Exhibit 9 - Public Comments

From: Christa Friedrich
To: [Lauren Anderson](#)
Subject: File No. CAO18-003, Property located at 8114 West Mercer Way
Date: Wednesday, July 11, 2018 3:37:23 PM

Re: File No.: CAO18-003

ercer Wetland

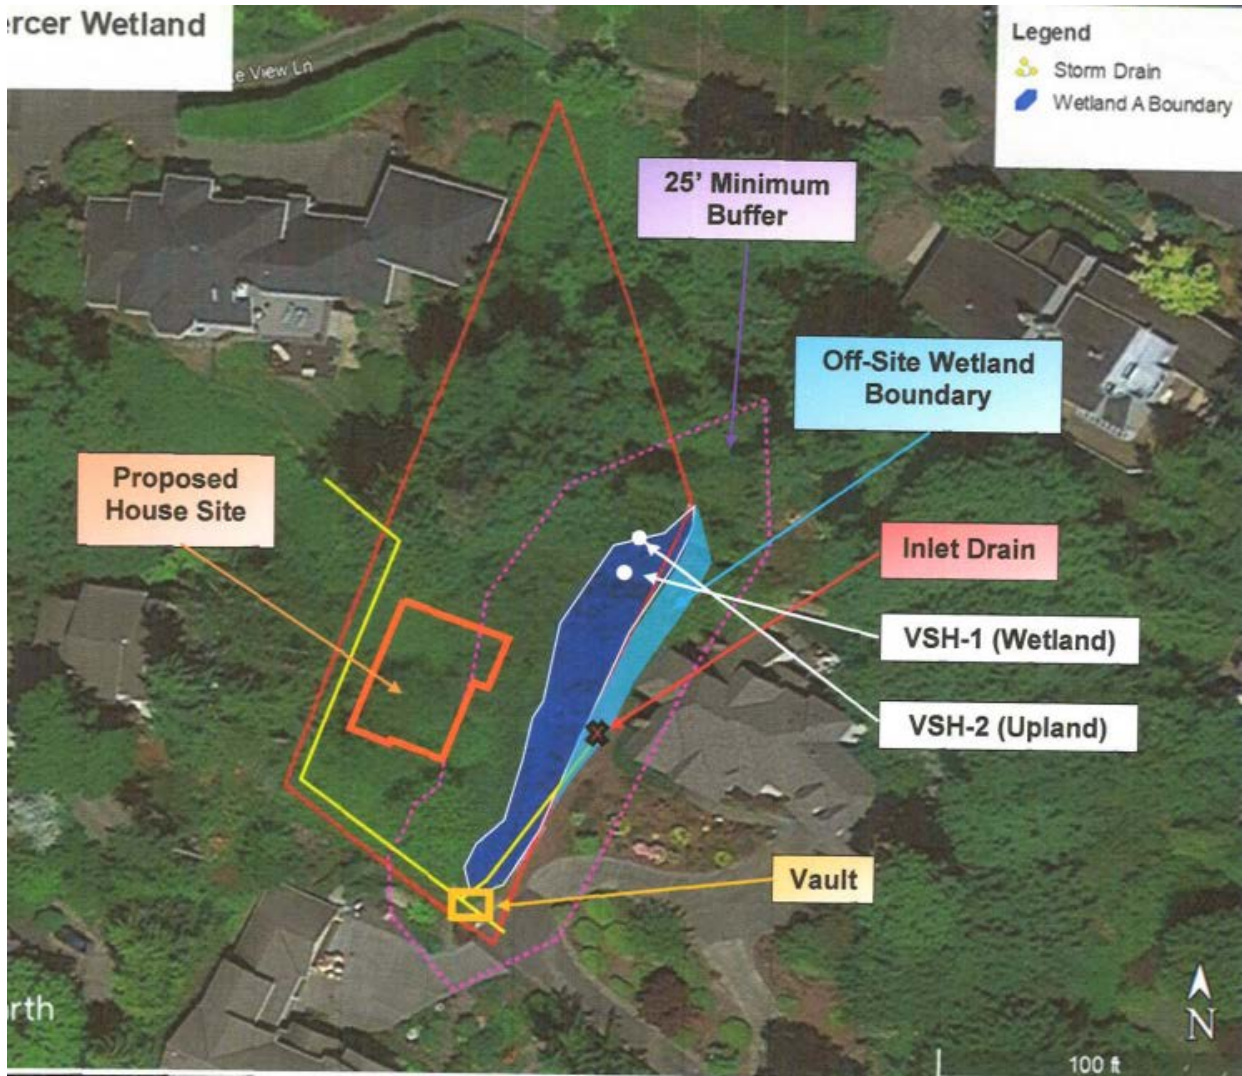
Lauren, I wanted to reach out regarding the proposal CAO13-03. I am the owner of 8122 W. Mercer Way, the property directly below the proposed changes to the minimum buffer. I have some significant concerns regarding the proposal and the vague nature of both the proposal and the impact. If they are proposing a reduction of the minimum buffer in some areas, where is the impact analysis to overall erosion and potential damage down-hill to our property? Also, what is the proposed plan to compensate for the reduction of the wetlands in the proposal?

In addition, we consulted with another consultant who informed us that the outline below is missing another wetland on the property. I would like to request an additional survey to ensure that all wetland impacts and potential damage to both the environment and to our property are understood, taken into account and mitigation plans developed.
